MY02 MONITORING REPORT

Hip Bone Creek Restoration Site

MEMORANDUM

Date: February 9, 2023
To: Jeremiah Dow, DMS Project Manager
From: Adam Spiller, Project Manager
KCI Associates of North Carolina, PA
Subject: MY-02 Monitoring Report Comments
Hip Bone Creek DMS#100059, Contract 007528
Cape Fear River Basin CU 03040101
Chatham County, North Carolina

CURRENT CONDITIONS PLANVIEW PAGE
HIP BONE CREEK RESTORATION SITE
CHATHAM COUNTY, NC

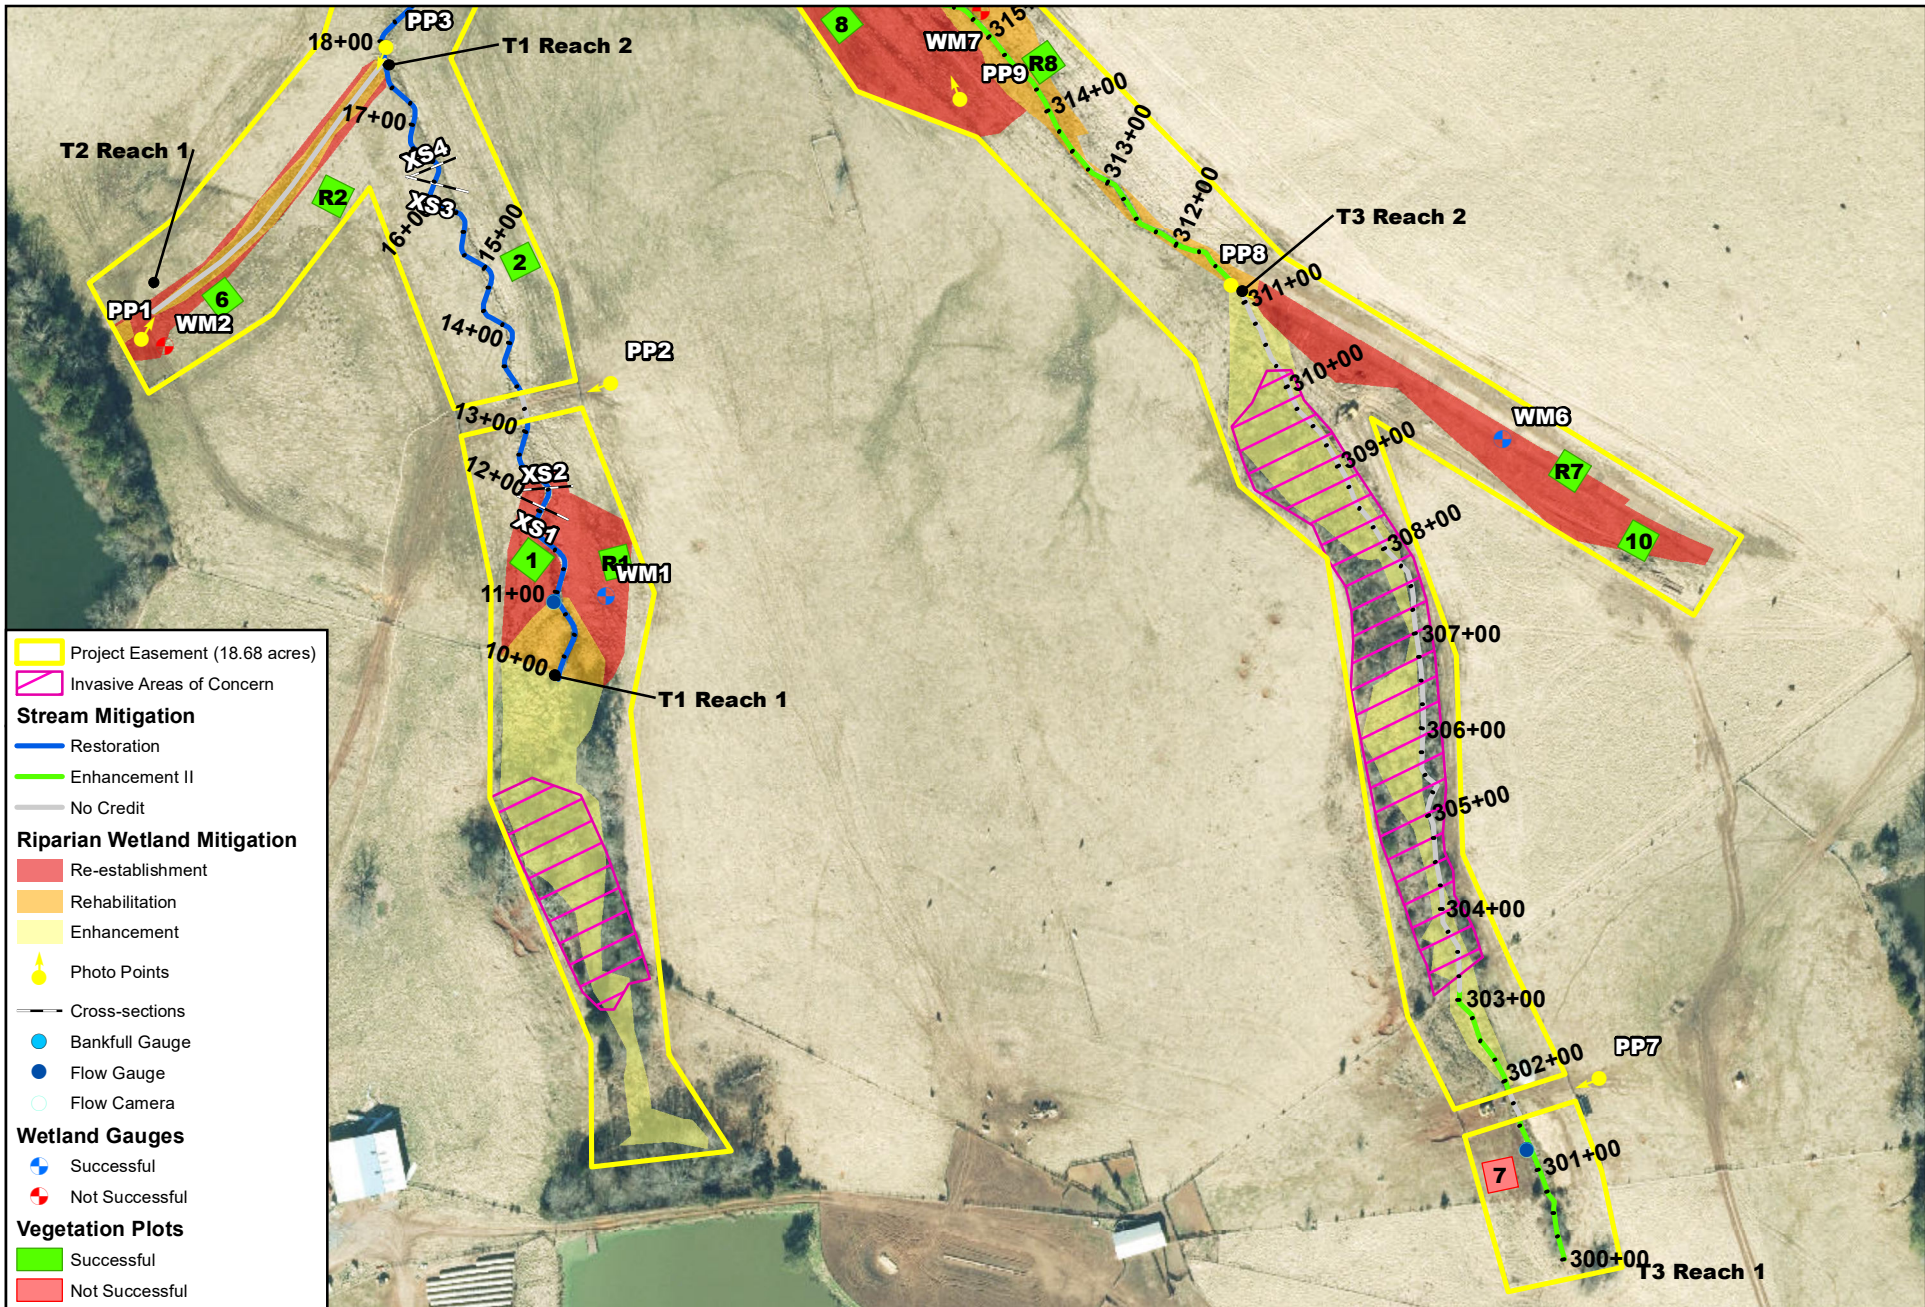
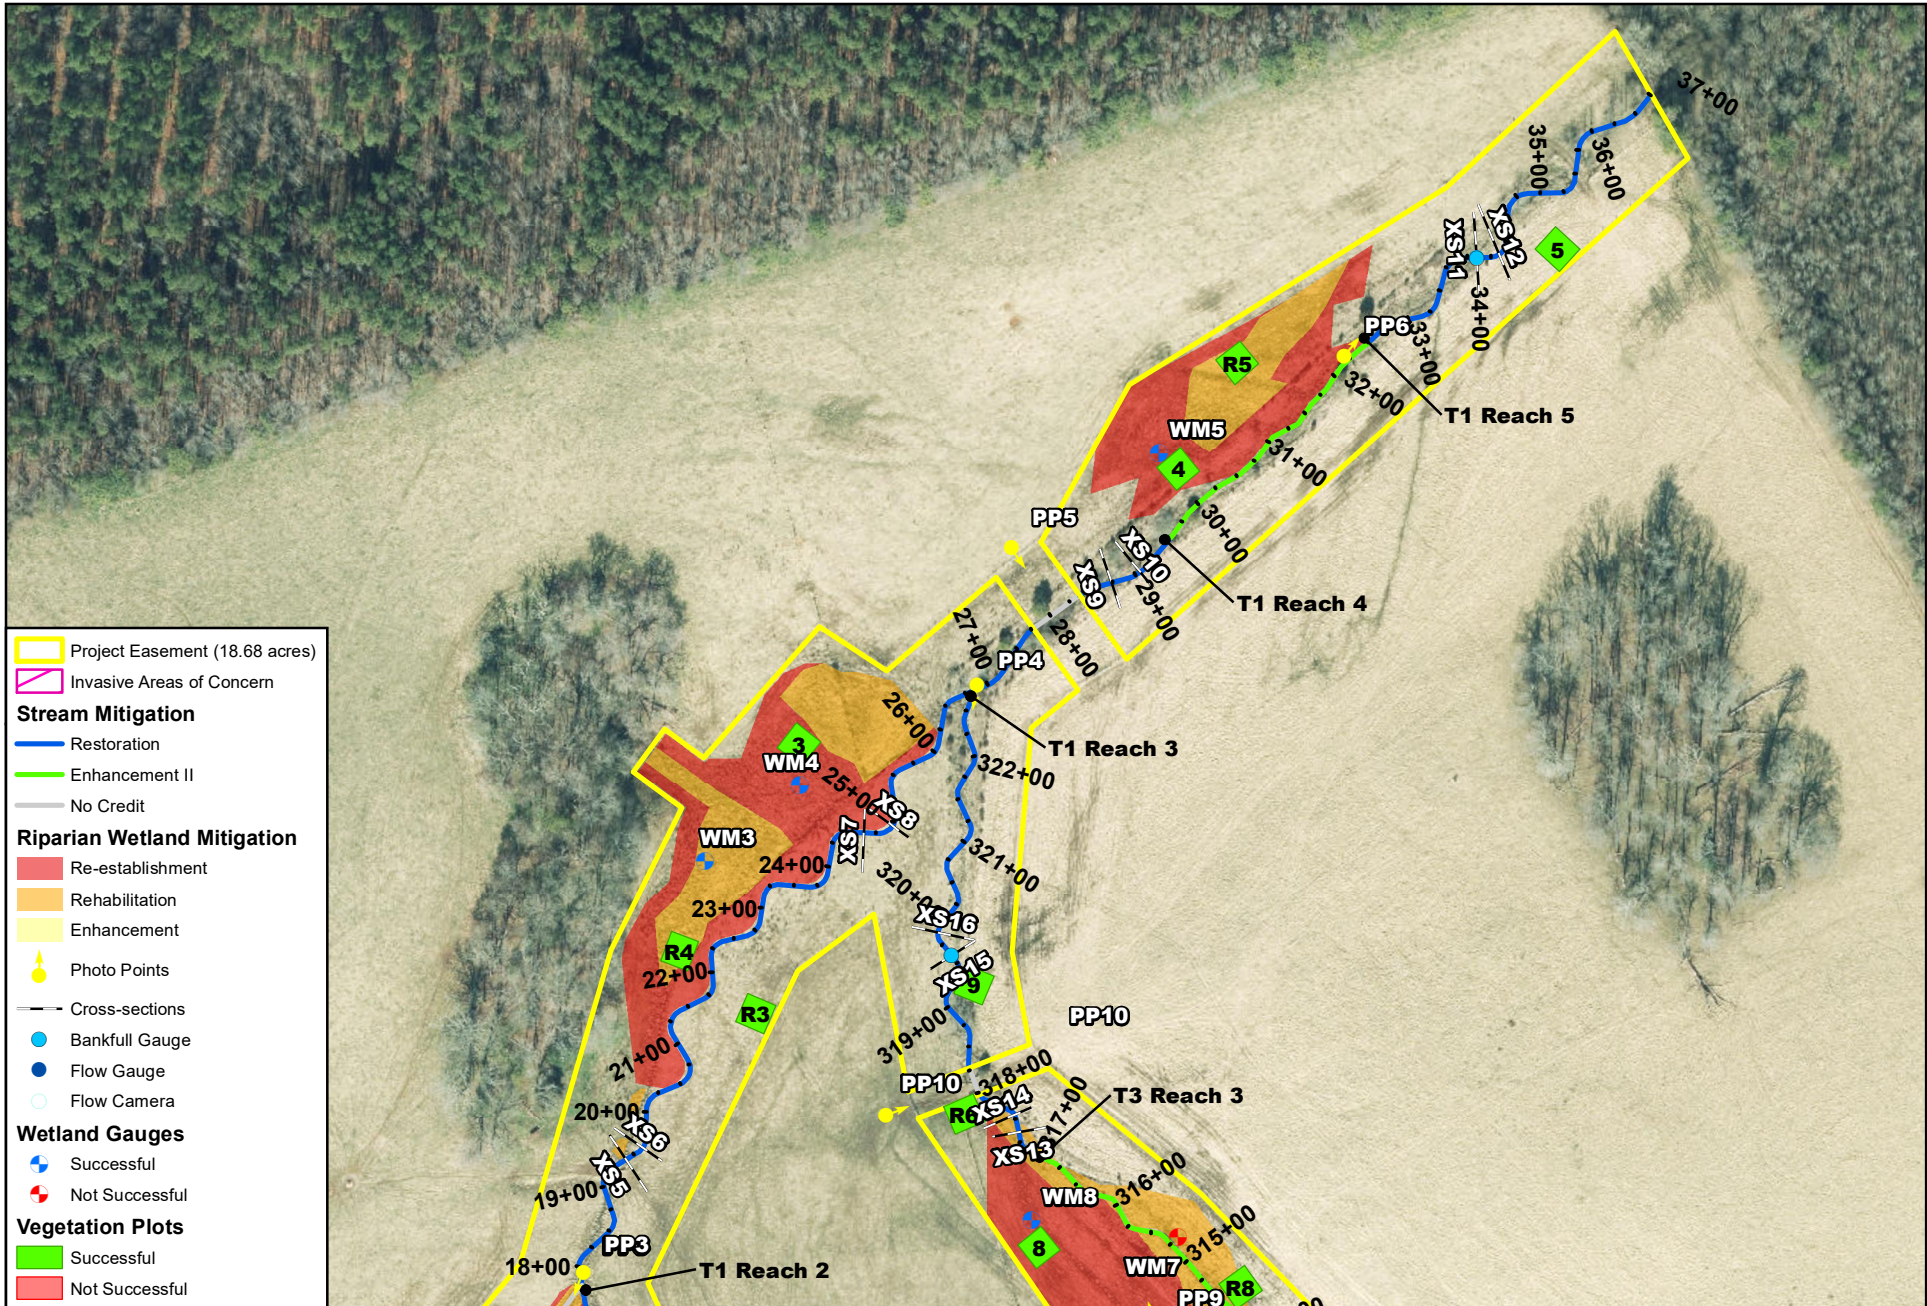
1. Please update the wetland credits in the CCPV Legend to match the project credits in Table 1.
KCI Response: This error has been corrected.
2. VP 7 is colored red on the CCPV. Is this due to only having 3 species in the plot since it met the stem/acre interim success criteria? Please clarify.
KCI Response: That is correct, VP7 is colored red due to having only 3 different species.

3. The wetland gauges on the CCPV are not colored correctly according to successful/not successful. For example, WM4, WM5, and WM8 are incorrectly shown as not meeting success and WM 7 is shown as meeting when it did not.
KCI Response: This error has been corrected.

Hip Bone Creek Restoration Site Hydrograph Wetland Gauge 1

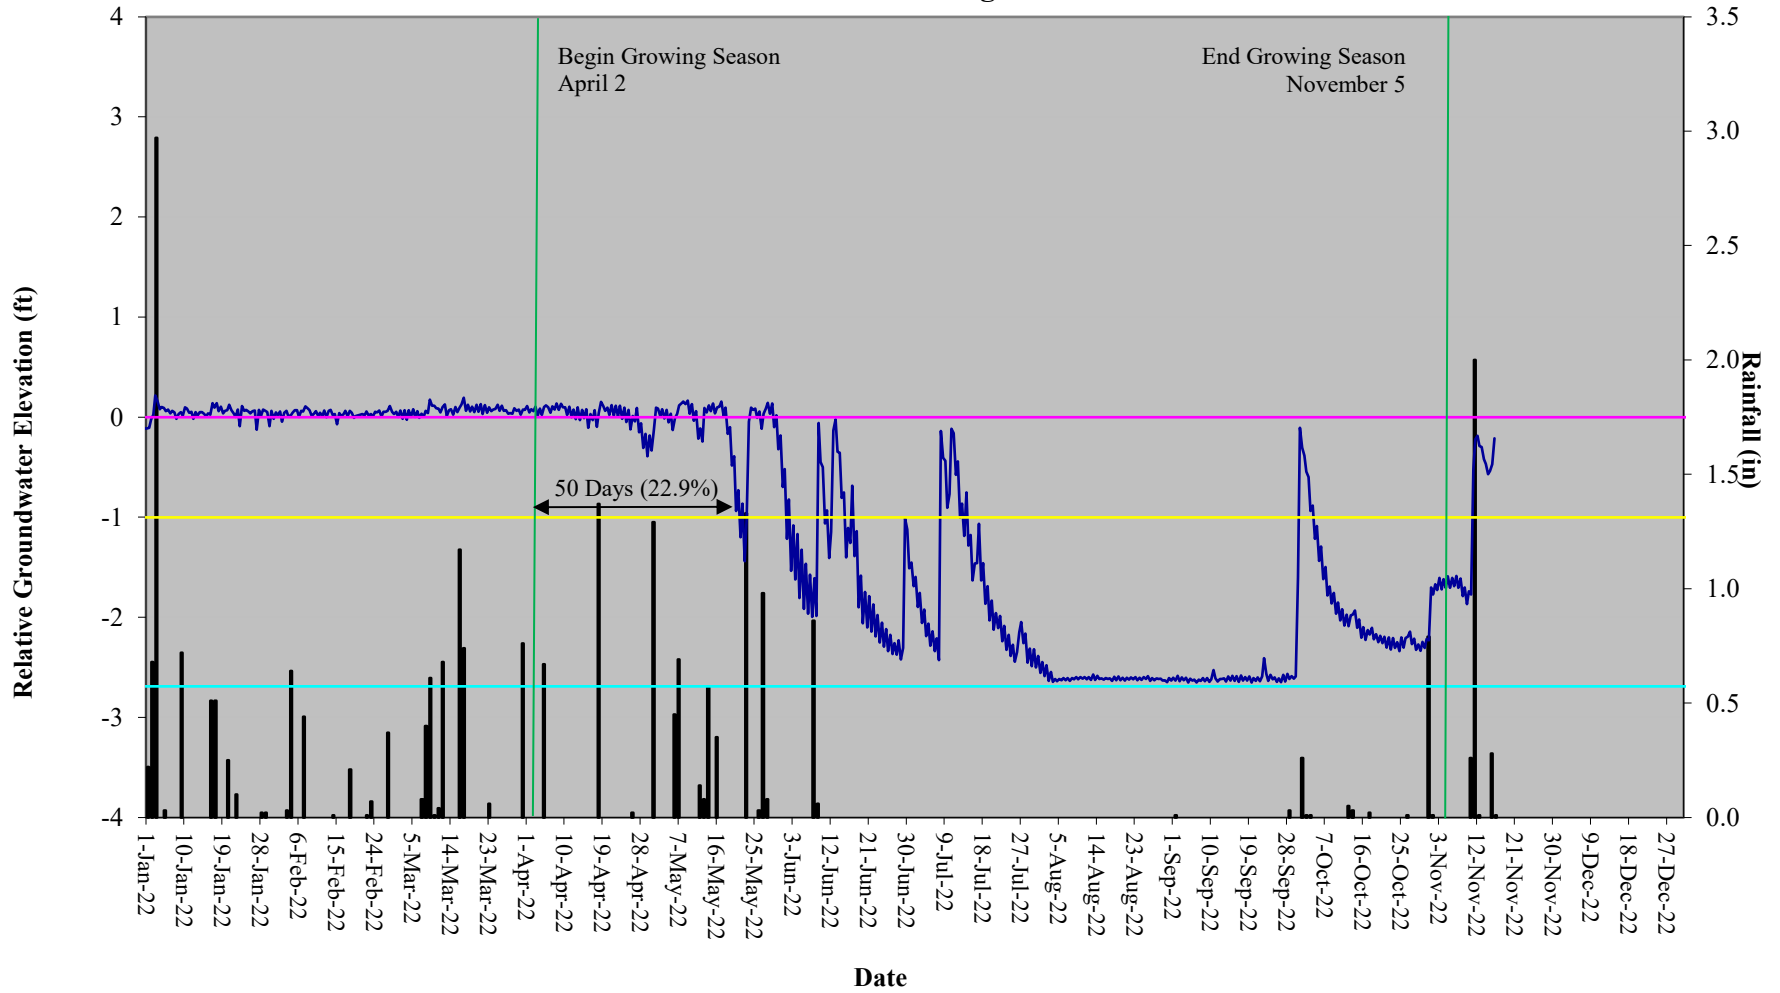
6. Would be useful to add hydroperiod percentage beside number of days on hydrographs, i.e., 50 Days/22.9% for WM-1, etc.
KCI Response: This change has been made.
